Proposal for a Definition of the FlexPLI Biofidelic Assessment Interval (BAI)

6th Meeting of Informal Group GTR9 Phase 2
Washington DC, March 19th - 20th, 2012

Oliver Zander
Bundesanstalt für Straßenwesen

GTR9-5-08 – Trial

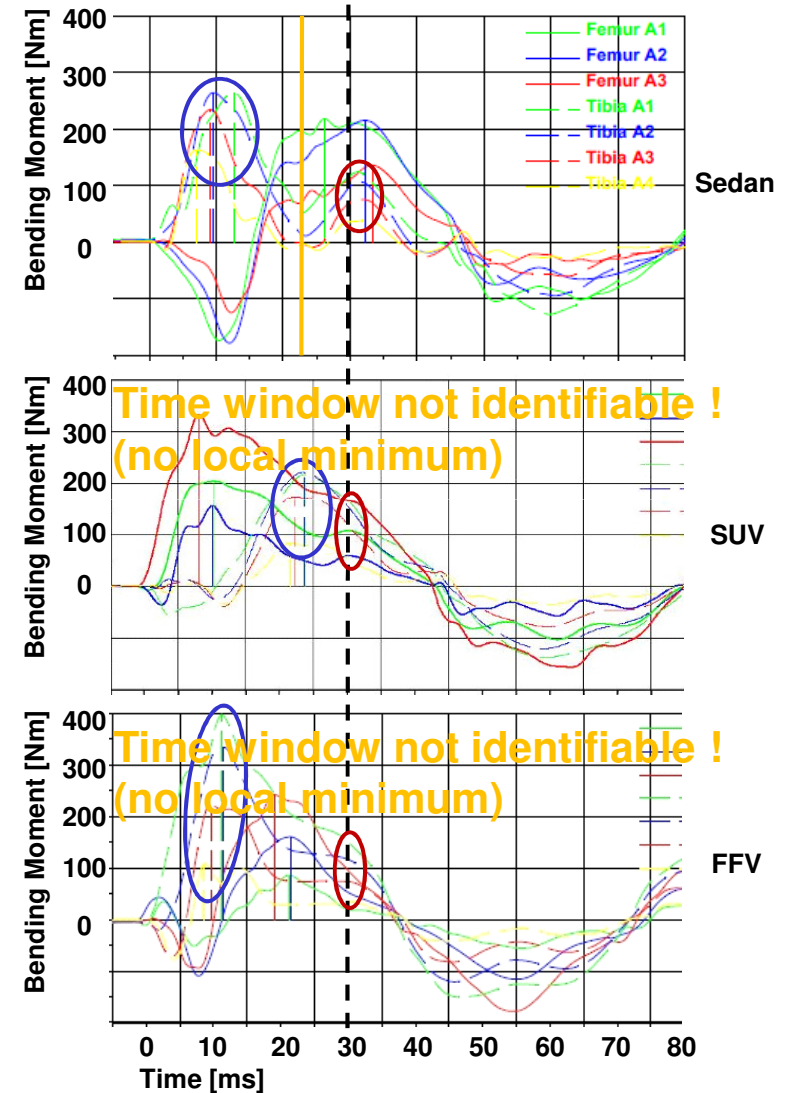
- Local peak bending moments are clearly defined before 30 ms

- ✓ Sedan → pass
- ✓ SUV → pass
- ✓ FFV → pass

- Overall maximum value is determined after 30 ms

- Sedan → fail
- SUV → fail
- FFV → fail

- Bending moment increase (A) of the channel providing the maximum value of the four channels after 30 ms is greater than 170 Nm

- Sedan → fail
- SUV → fail
- FFV → fail

Start of rebound phase ?

- **This procedure obviously is quite complex and covers not all cases.**
- **As demonstrated, in several cases an unlimited time window including actual rebound impactor movement would be considered for the tibia bending moment assessment. This could lead to incorrect measurement interpretations and maxima determinations even during a possible rebound phase.**
- **To ensure a correct assessment during an automatic evaluation the procedure must cover all possibilities.**
- **Besides, considering only the tibia bending moments may lead to a wrong determination of the rebound phase starting point**
- **The determination of the rebound phase is based on maximum values *during* the rebound phase whereas the whole rebound phase is assumed not to give realistic and reproducible measurements.**

GTR9-5-30 – Case study (I): Sedan

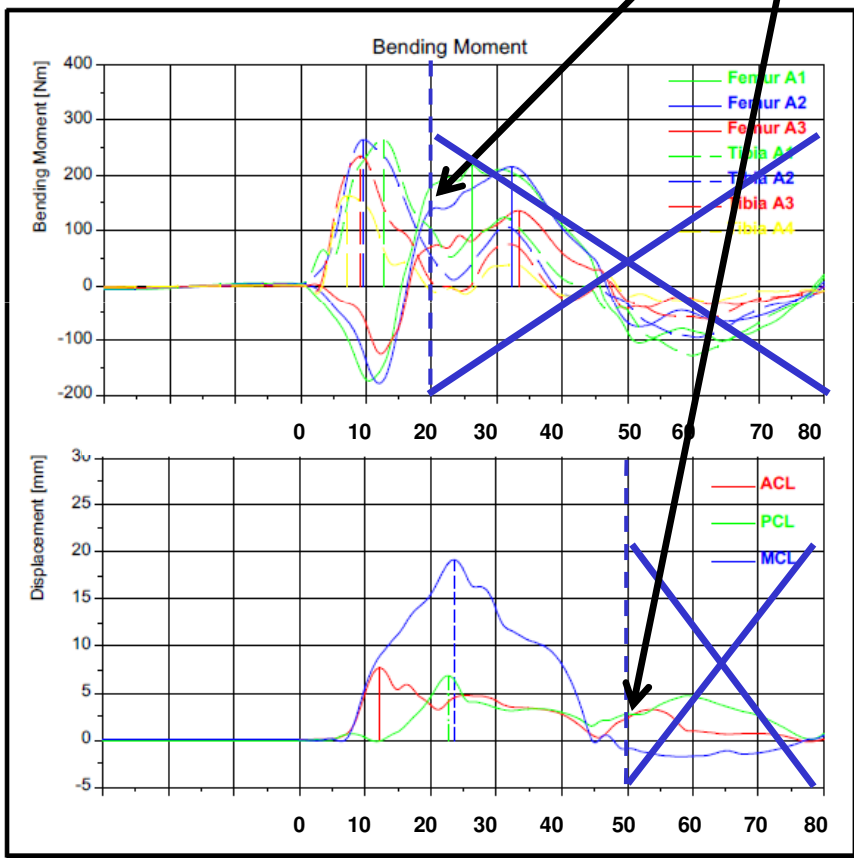
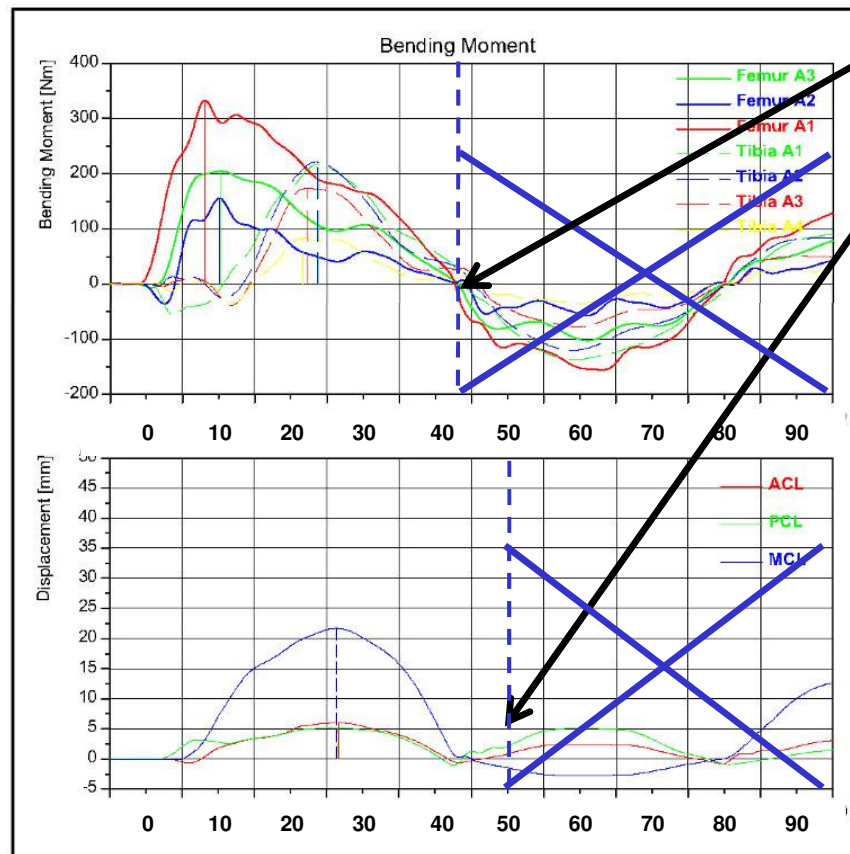
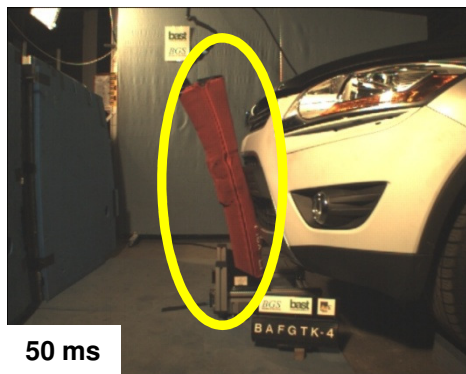
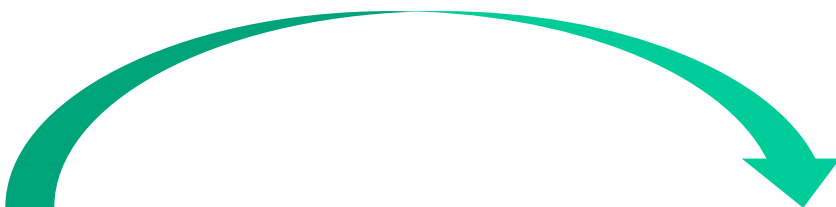
Rebound ?

too early !

too late !

GTR9-5-30 – Case study (II): SUV

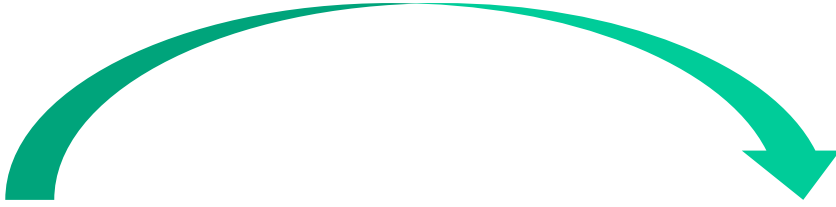
Rebound ?

approx. ok !

too late !

GTR9-5-30 – Case study (III): FFV

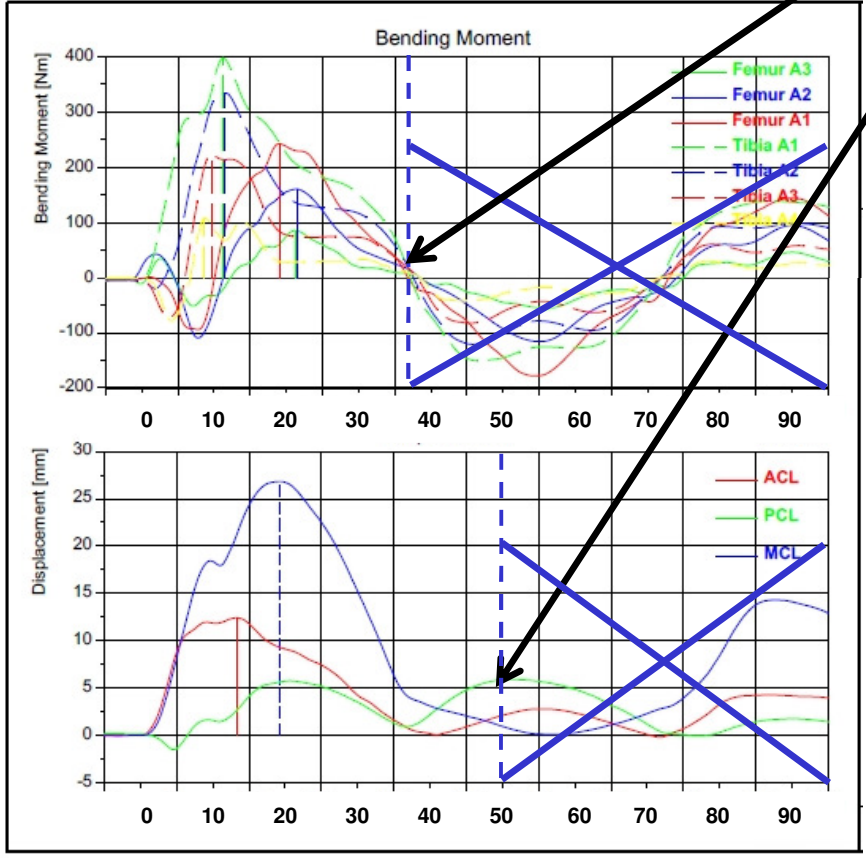
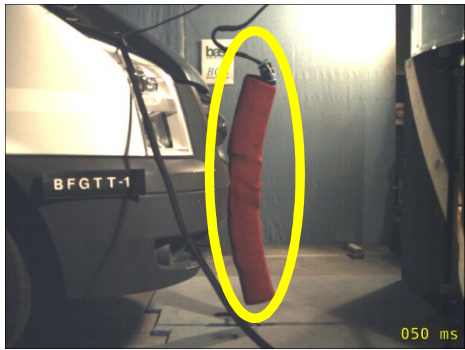
Rebound ?

approx. ok !

too late !

GTR9-5-30 – Case study (IV): Sports car

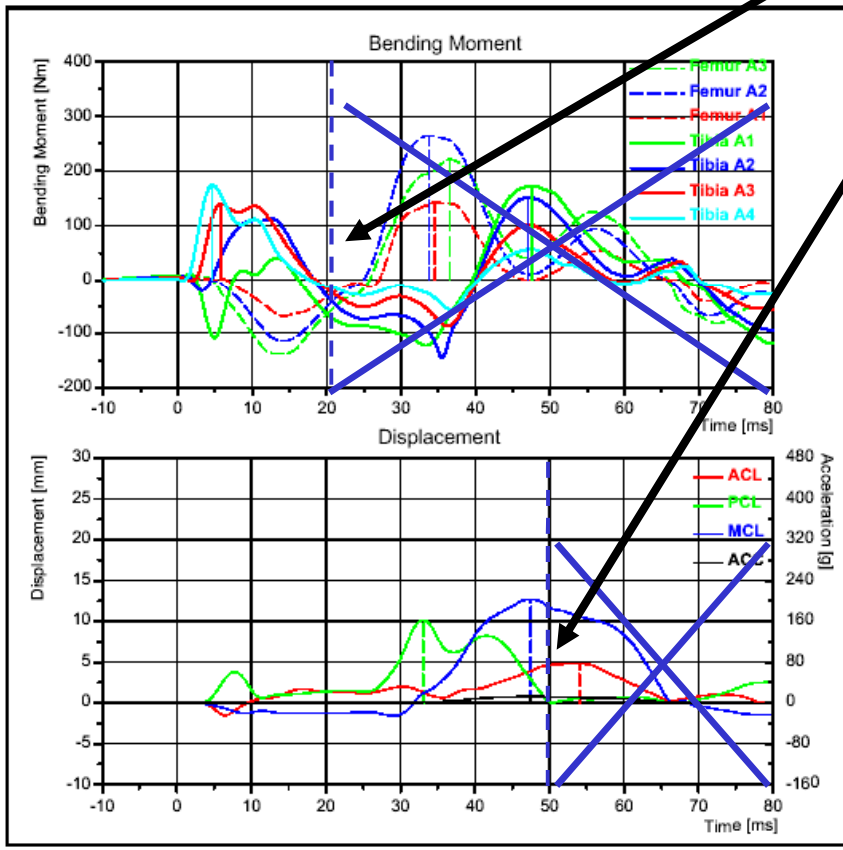
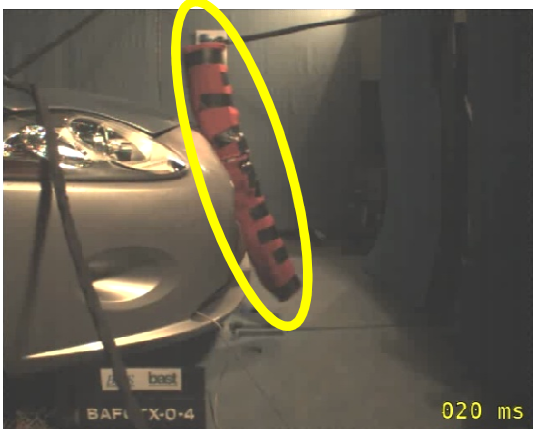
Rebound ?

too early !

too early !

- **This procedure distinguishes between tibia moments and knee elongations**
- **The use of the first zero crossing of only one tibia moment can lead to rebound starting points that are too early**
- **The procedure is a pragmatic approach but seems not precise enough: Rebound phase starts too early or too late in some cases.**
- **The use of a fixed time interval (50 ms) is not appropriate because in some cases the maximum loadings occur later.**
